KINGSTON FOSSIL PLANT (KIF) - ANNUAL INSPECTION OF WASTE DISPOSAL AREAS

***ANNUAL INSPECTION OF
WASTE DISPOSAL AREAS***

**KINGSTON FOSSIL PLANT
NPDES PERMIT NO. TN0005452
ANNUAL ASH POND DIKE INSPECTION
1998**

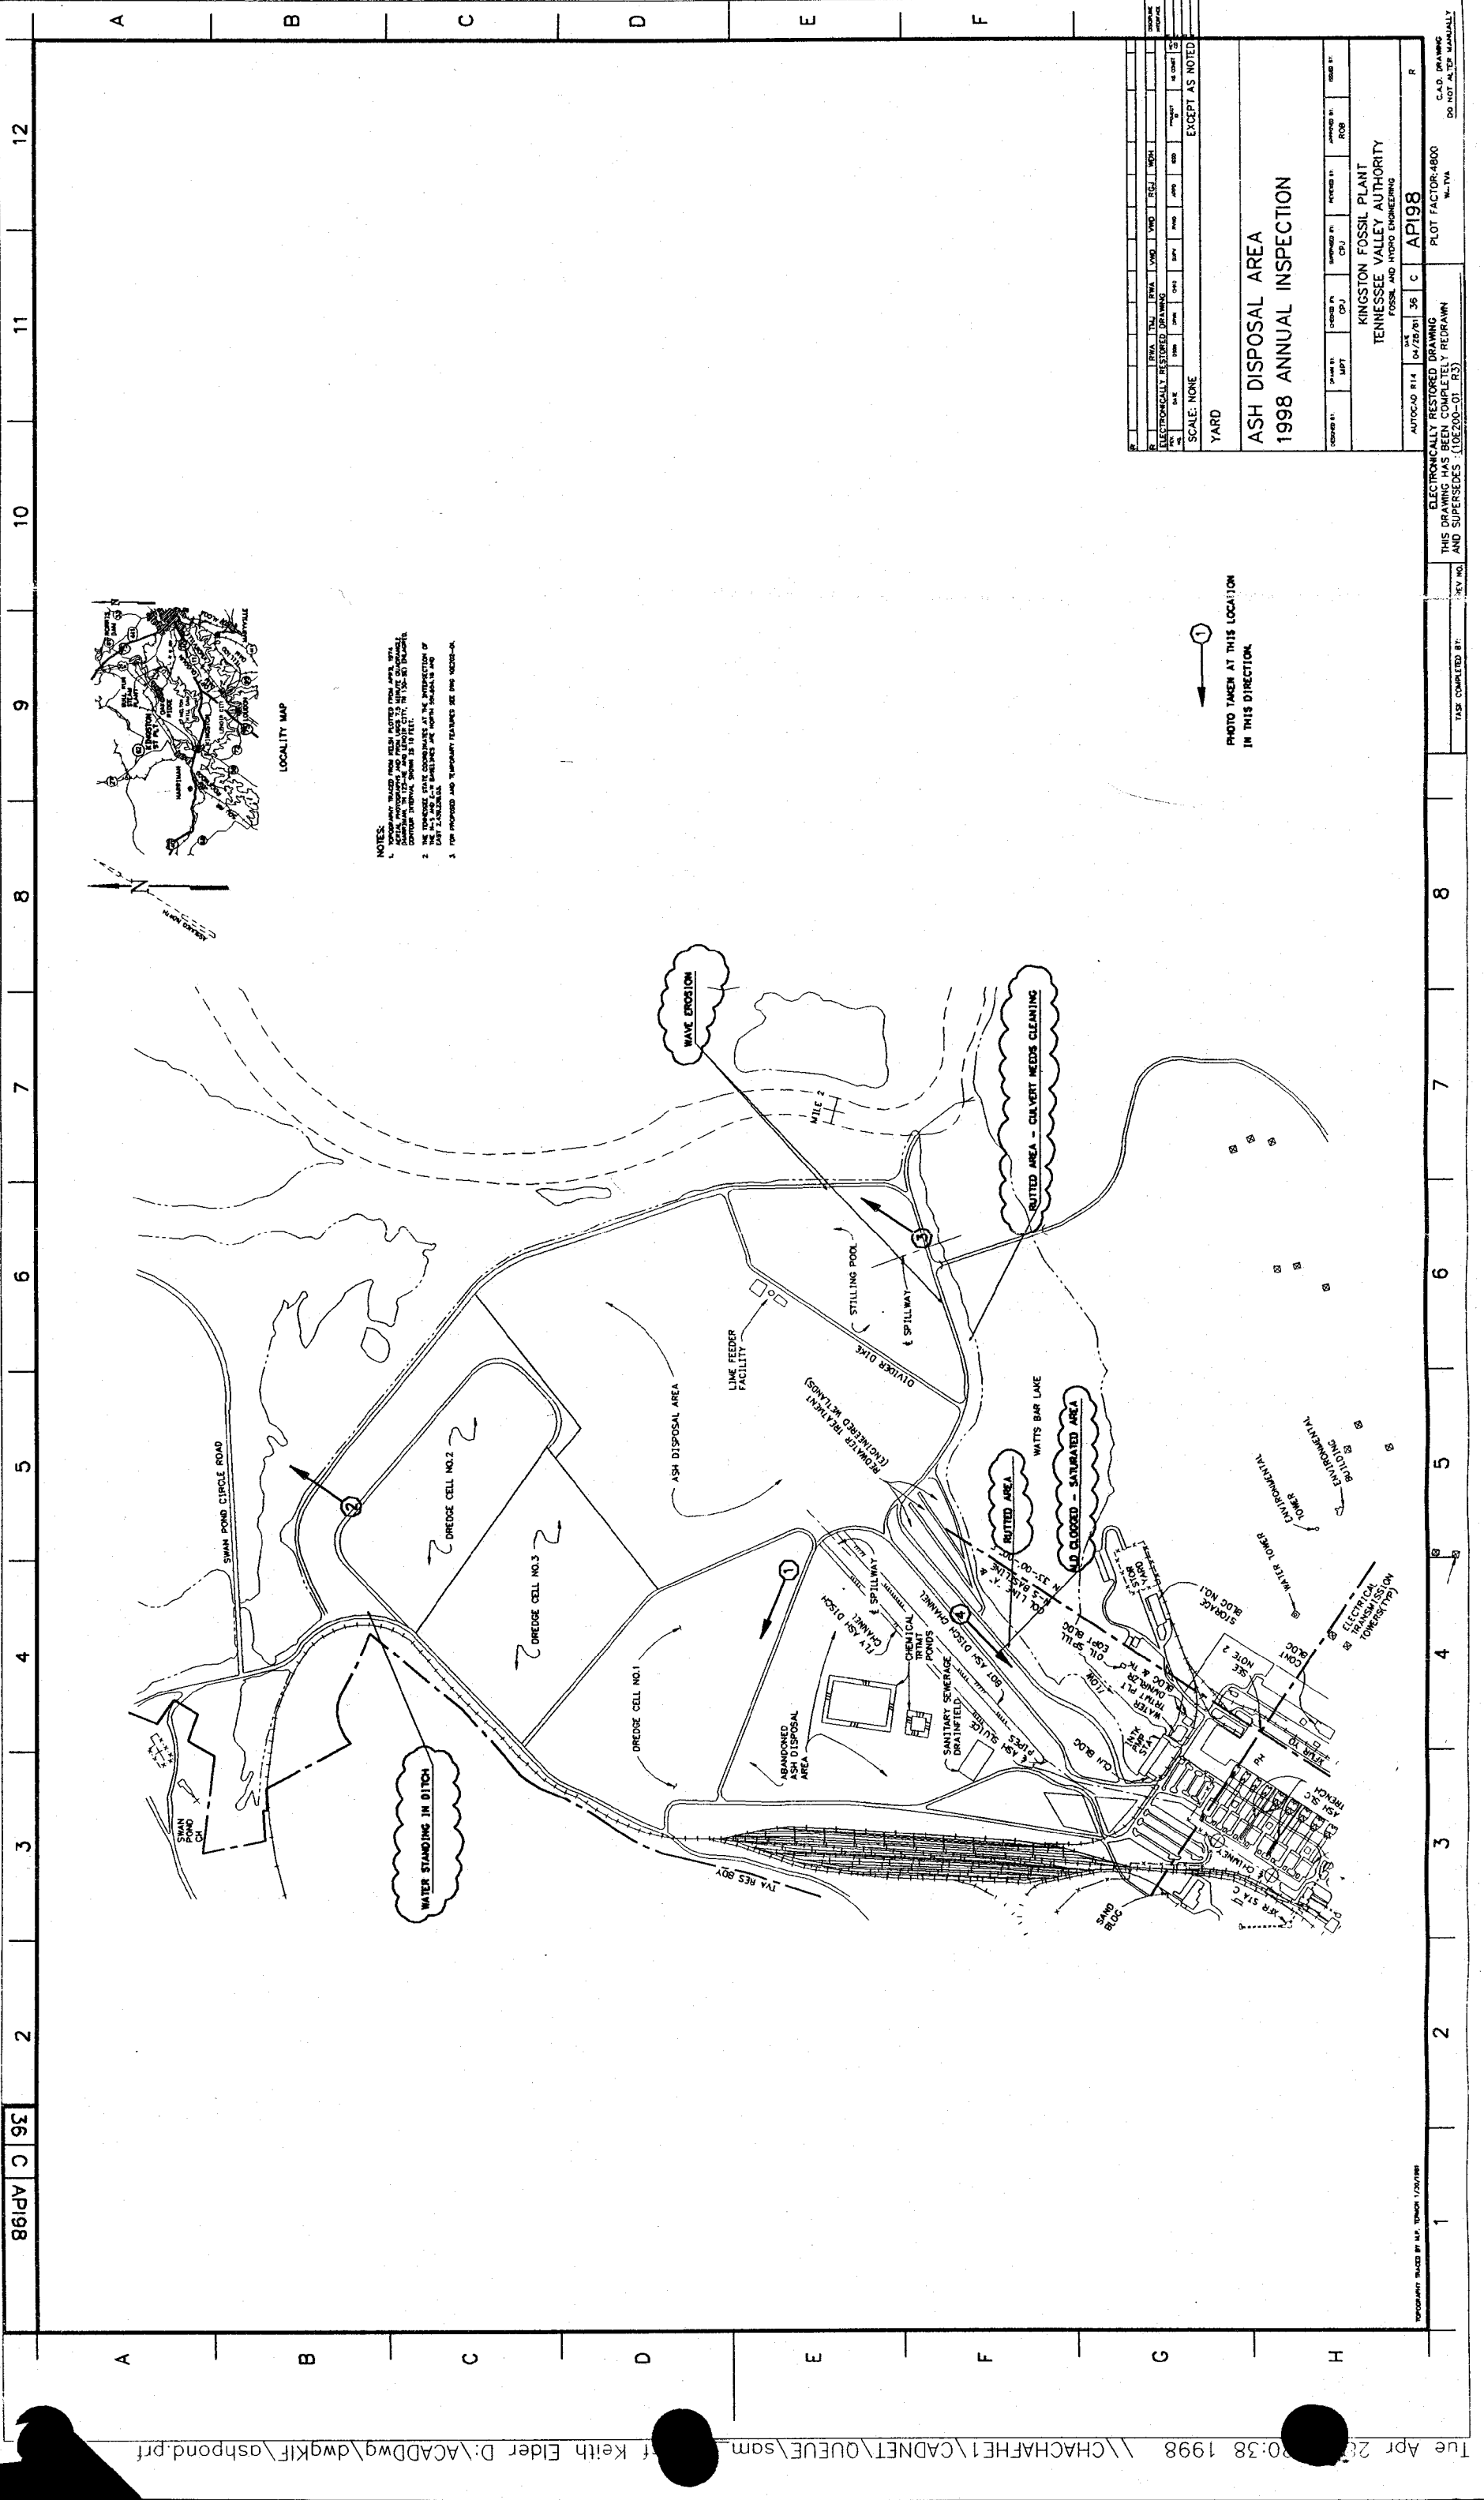
The dike slopes around this area were all stable and had excellent vegetative cover. Plant operations continue to do a commendable job of mowing the slopes. The previously identified minor slough on the west end of dike "C" had not changed in size or appearance. An area of ponded water was along the toe of the northwest dike in the ditch between the road and the dredge cells. Two erosion gullies were noted adjacent to the perimeter ditch along the northwest corner of Dredge Cell 2.

Figure 3. Wave erosion on northern interior slope of the stilling pond.

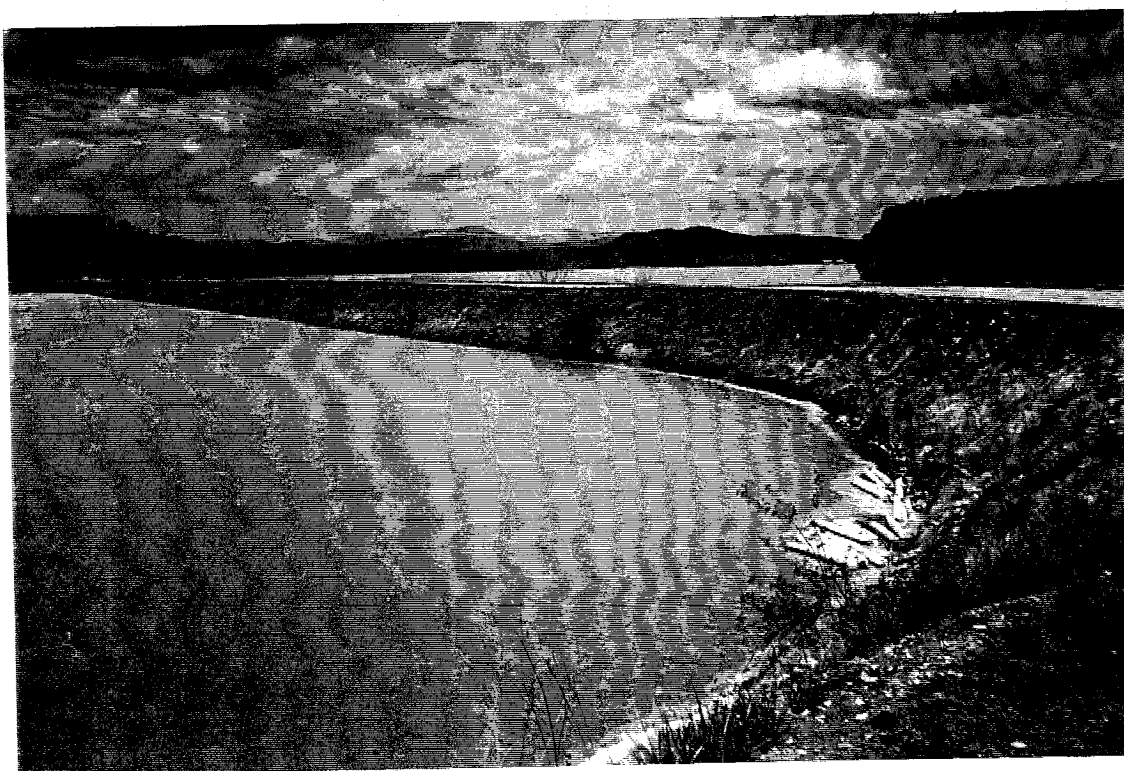
All exterior dike slopes around this area were in sound condition with excellent vegetative cover. The vegetation had been mowed and no signs of trees were present on any dike slopes. No new sloughs were detected, and the previously identified ones had not changed. There was evidence of wave erosion on the interior dike slopes of the stilling pond. The divider dike between the active pond and the stilling pool was in good condition with minor erosion on its slopes. Two areas of note were found--along the eastern dike and along the southern dike west of the bridge. Otherwise, these slopes had good vegetative cover. The dike roads were in good condition with the exception of two segments that were rutted along the southeastern dike--one west of the bridge over the intake channel and one adjacent to the anoxic limestone drain southwest of the engineered wetlands.

- Plant personnel should repair the areas of wave erosion on the interior dikes of the stilling pool by placing riprap in the problem areas where the slope has a visible vertical face of 1 foot or more.
- The ruts along the southeastern roads should be repaired by scraping away the soft material, replacing with firm clay material, and compacting. The drainage culvert under the road west of the bridge should either be replaced or cleaned out so that the area will drain and prevent future rutting.
- The drainage ditch at the toe of the northwest corner of the area should be graded to drain. Any disturbed areas resulting from this work should be seeded and mulched.
